Well Name: ROBIN FED COM	Well Location: T20S / R34E / SEC 20 / NWSW /	County or Parish/State:
Well Number: 131H	Type of Well: OIL WELL	Allottee or Tribe Name:
Lease Number: NMNM13276	Unit or CA Name:	Unit or CA Number:
US Well Number: 3002552585	Well Status: Approved Application for Permit to Drill	Operator: COLGATE OPERATING LLC

Sundry ID: 2775877

Type of Submission: Notice of Intent	Type of Action: APD Change
Date Sundry Submitted: 02/24/2024	Time Sundry Submitted: 08:28
Date proposed operation will begin: 03/08/2024

Procedure Description: 30-025-52585 Colgate respectfully requests to make changes to the Robin Fed Com 131H APD as follows: We would like to change the SHL (*No additional surface disturbance), FTP, LTP and BHL as follows: SHL: *No additional Surface Disturbance From: 1480 FSL & 1285 FWL, Sec 20, 20S, 34E, Unit L To: 1480 FSL & 1315 FWL, Sec 20, 20S, 34E, Unit L, No changes in lease number FTP: From: 1420 FSL, 330 FWL, Sec 20, 20S, 34E, Unit L To: 100 FSL, 1210 FWL, Sec 20, 20S, 34E, Unit M, New lease number NMNM105821031 LTP: From: 100 FNL, 330 FWL, Sec 17, 20S, 34E, Unit D To: 100 FNL, 1210 FWL, Sec 17, 20S, 34E, Unit D, No changes in lease number BHL: From: 10

1 API Number		2 Pool Code 37580		3 Pool Name Lea; Bone Spring, South	
4 Property Code		5 Property Name ROBIN FED			6 Well Number 131H
7 OGRID No. 371449		8 Operator Name Colgate Operating, LLC			9 Elevation 3657.34'

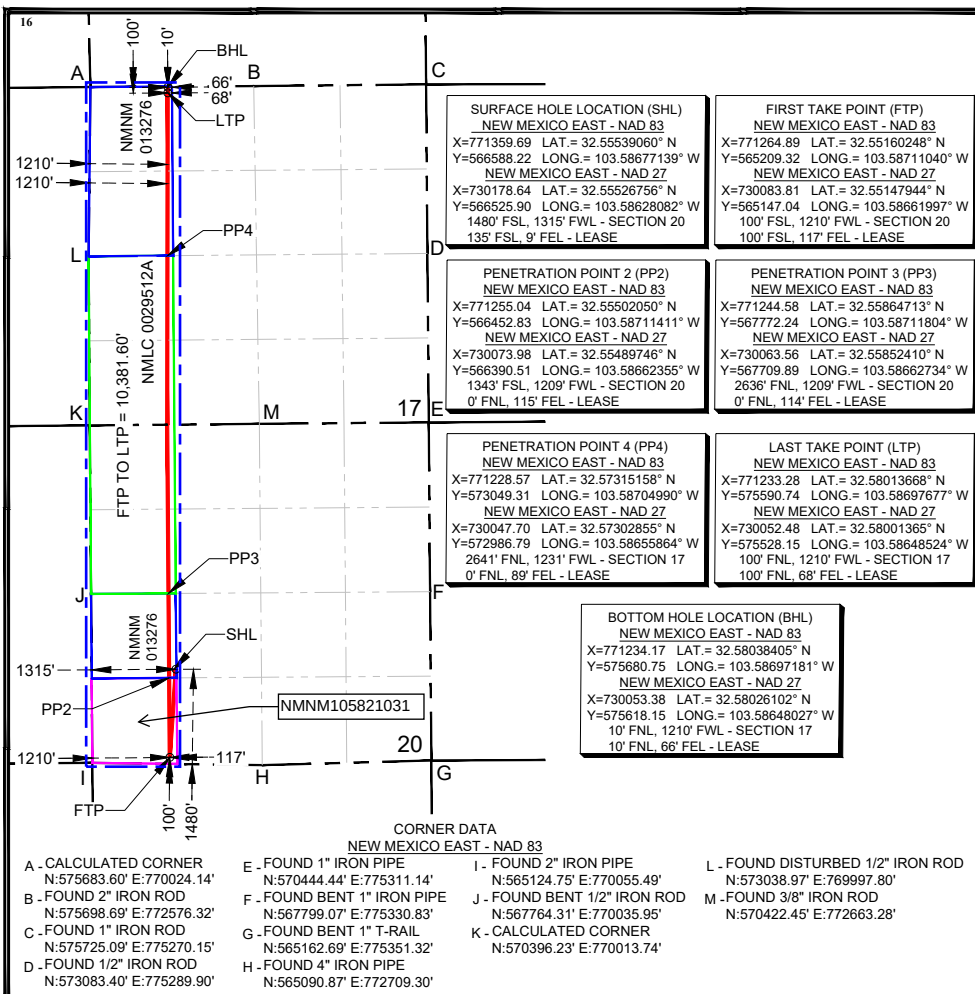
To: 100 FSL, 1210 FWL, Sec 20, 20S, 34E, Unit M, New lease number NMNM105821031

To: 100 FNL, 1210 FWL, Sec 17, 20S, 34E, Unit D, No changes in lease number

To: 10 FNL & 1210 FWL, Sec 17, 20S, 34E, Unit D, No changes in lease number
